30-045-25892 ROURKE #001E

**** BLM REVISED ** BLM REVISED ** BLM REVISED ** BLM REVISED ** BLM REVISED ****

P&A - Notice of Intent

Re: Permanent Abandonment
Well: Rourke 1E

Schematic - Current
Well Name: ROURKE #1E

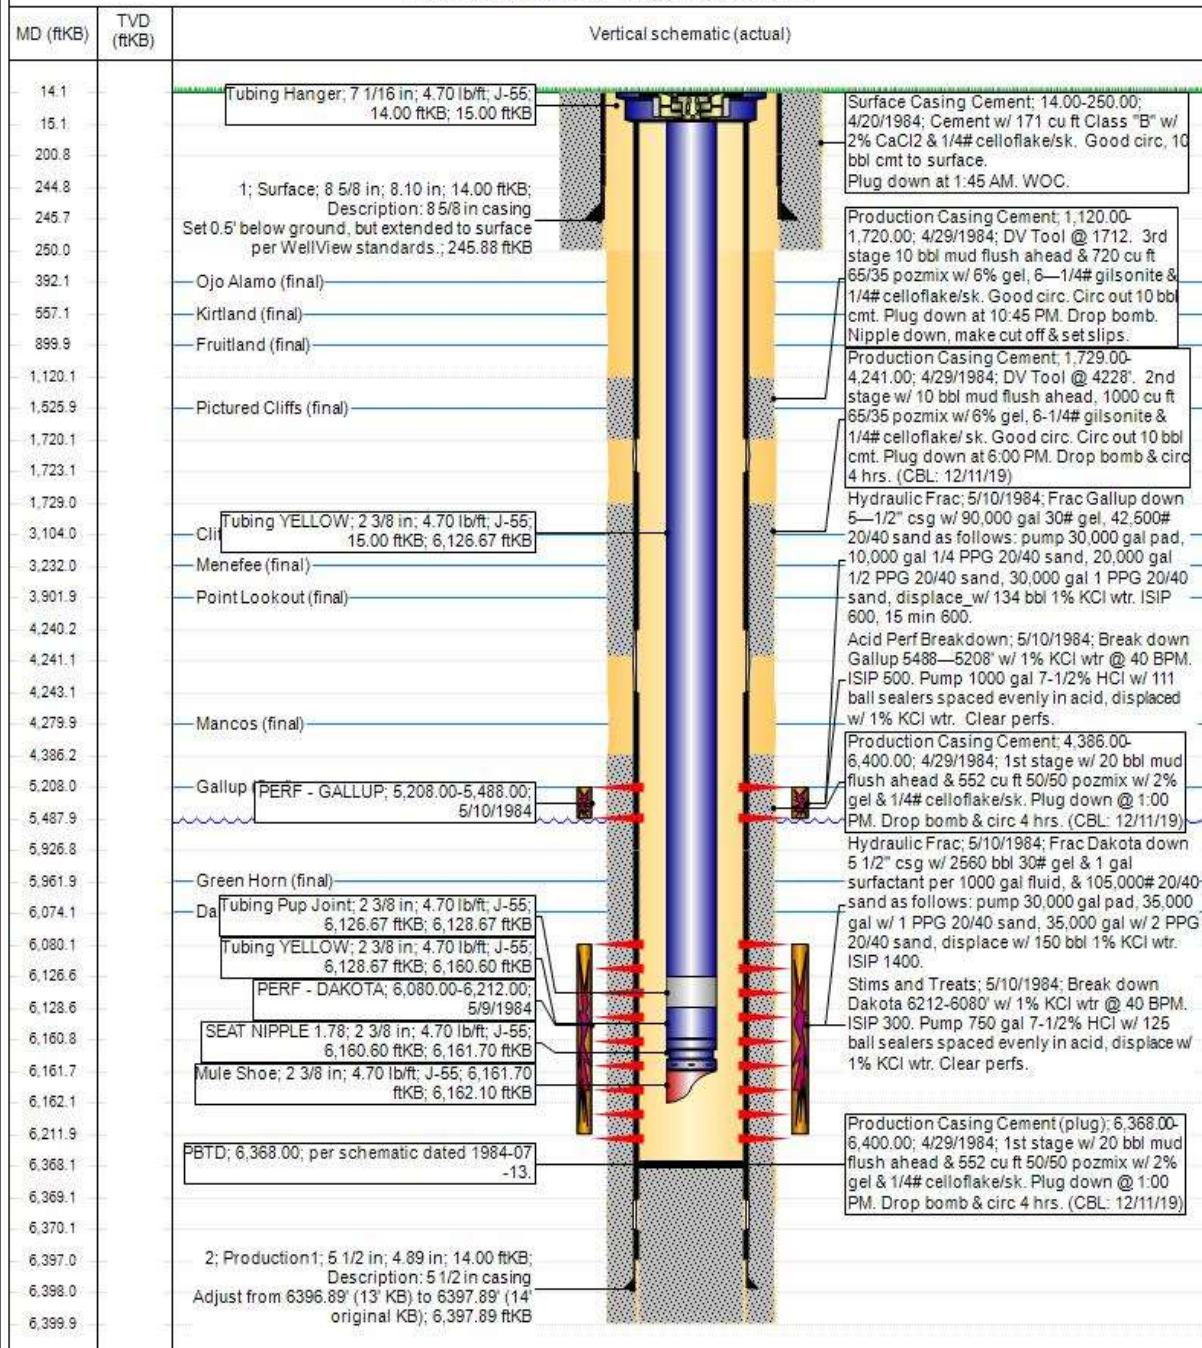
- Add a Dakota plug: 6030'-5975'. OCD Graneros pick @ 6025'.
- Add a Gallup plug 5260'-5160'. OCD Gallup pick @ 5210'.
- Add another Fruitland plug 1160'-1060'. OCD Fruitland pick @ 1110'.

Ensure plugs 3 and 7 reflect corrections below provided by operator:

Plug #3: balance plug in casing
3154-2288' = 113 CUFT = ~99 sx
Originally called for 72 sx.

Plug #7: inside outside plug
442-0' = 35 CUFT (inside) + 150 CUFT (behind pipe including excess) = ~165 sx
8.1" ID inside 8-5/8" 24# csg
Originally called for 110 sx.

4. BLM picks Mancos top at 4260' md. Ensure plug covers 4210-4310 and includes required excess.

Probable fresh water exists in the McDermott Member of the Animas Formation down to the top of the Kirtland Fm. Please ensure that the tops of the Pictured Cliffs and Fruitland formations as well as the entire McDermott interval, identified in this report, are isolated by proper placement of cement plugs. This will protect the freshwater sands in this well bore.
